City of Oxford
Community Development Department
STAFF REPORT

Board of Zoning Appeals

Case # BZA-08-2012

Applicant:	Scott Webb, Architect
Location:	201 East Chestnut Street
Owner:	Ashley at Chestnut, LLC (Bart Werpin, Manager)
Potential Buyer:	GMS Development (Guy Totino)
Action Requests:	Variance to Occupancy reduction 1137.08(e); Multiple buildings on a lot 1141.03(a); Front yard setback 1143.06(c)(2)(A); Lot coverage 1143.06(c)(4)(A)(1); Parking spaces 1149.03(e); Parking setback 1149.04(3); Parking islands 1149.05(e)(4)(F); Parking trees 1149.05(e)(5)(B)(1)(a); Perimeter screening 1149.05(e)(4)(B)
Current Use:	3 story multi-family residential
Zoning:	R-3, Multi-Family
Surrounding Land Uses:	Single and Multi-Family Residential

EXISTING SITE PLAN
DIMENSION PLAN
1" = 30'-0"

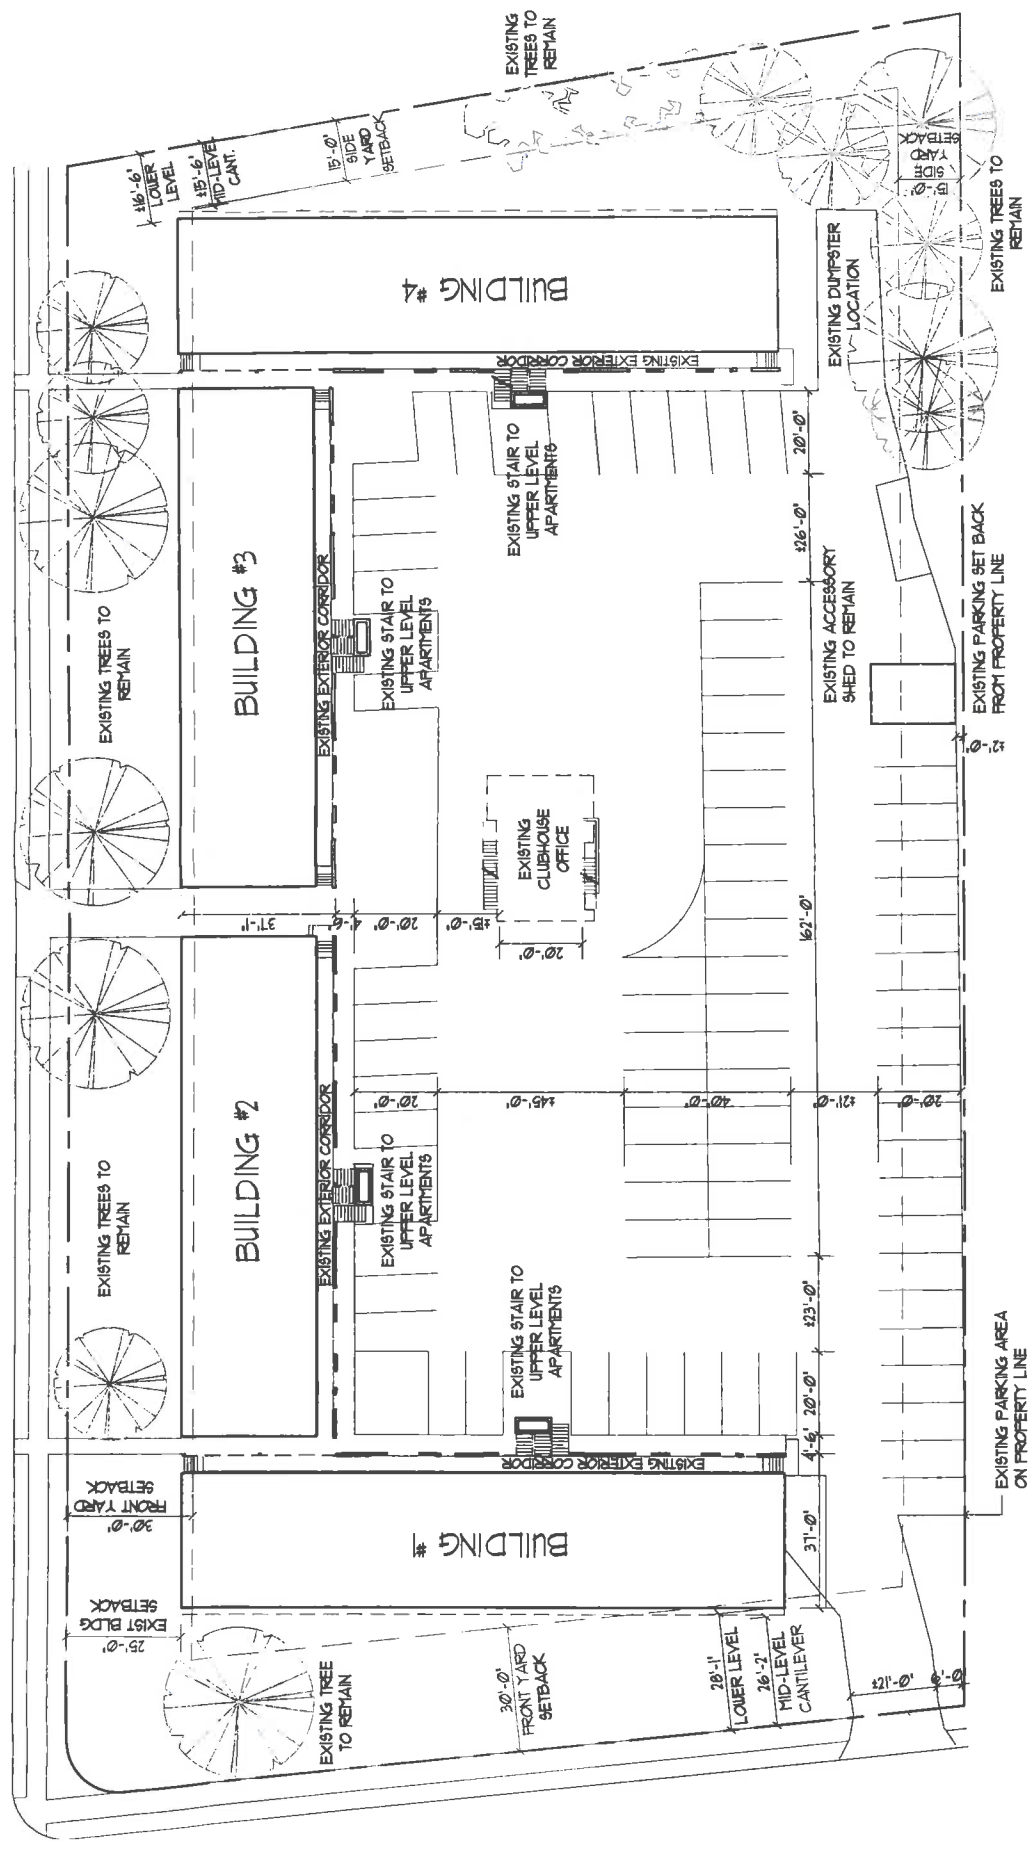
The front yard (setback) requirement when the buildings were built may have been 25 feet, which the buildings would comply with. However, the current requirement for the R-3 district is 30 feet. As shown on the attached site plan, nearly the entire façade encroaches into the front yard by 5 feet. The lower level is stepped back about two feet further away from the street than the upper two levels. The applicant is proposing to use the existing building shells, which are nonconforming, therefore is requesting a variance of 5 feet for the majority of the façade, with the exception of just the far

southwest corner, which is nonconforming by 8 feet.

A slight reduction in lot coverage is proposed (72.1% to 70.3%). However, this is still far from compliance with the current maximum of 35%.

The existing paved parking area along the south property line tapers to well below 3 feet.

The existing site has no interior landscaped islands. The proposed island is possible because of the removal of the common-use building in the center of the parking lot. Based on the number and location of rows of parking, at least 6 separate islands are required. Only one very long island is proposed.

The intent of the tree requirement is to have some parking lot landscaping within the parking area and directly adjacent. This breaks up extensive hard surfaces and adds to the general health and welfare of the area. The proposal adds trees (7) to the parking area, where possible, but does not meet the full requirement of 18 trees.

The existing and proposed parking spaces along the south property line are situated in such a way that cars which pull in, could have headlights projecting into the residential structures to the south. No screening is proposed by the applicant.

TOTAL OCCUPANCY: 176 TOTAL OCCUPANTS

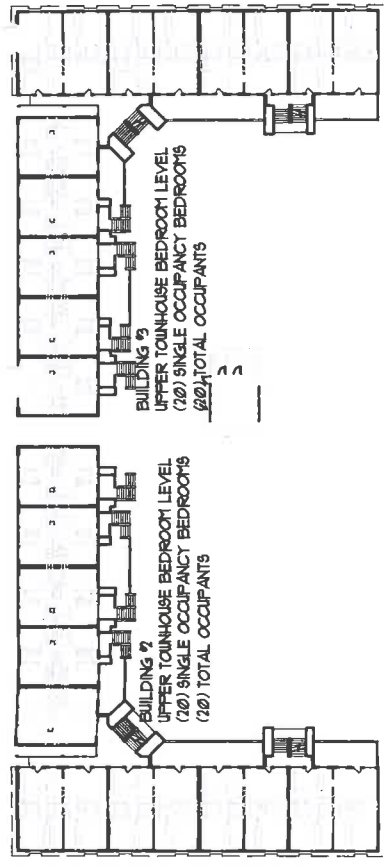
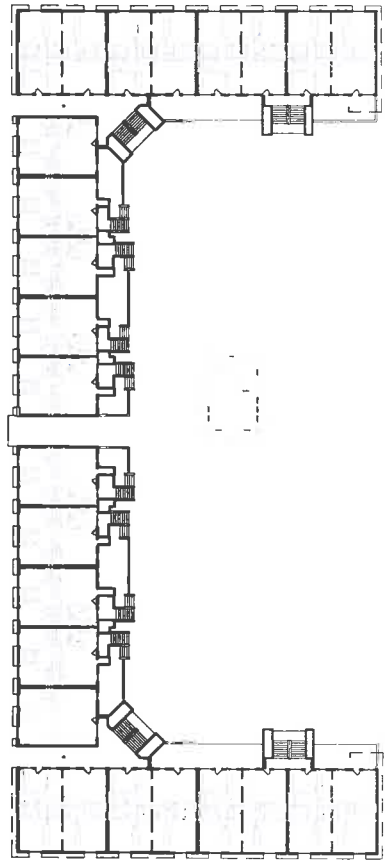
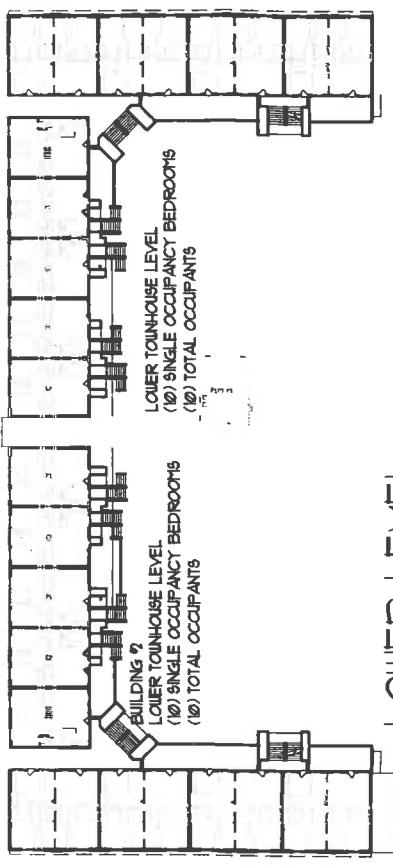
A total rehab of these buildings constitutes more than 75%, therefore the occupancy of these nonconforming buildings must be reduced by at least 20% -- which is from 216 to 173. The applicant is proposing 176.
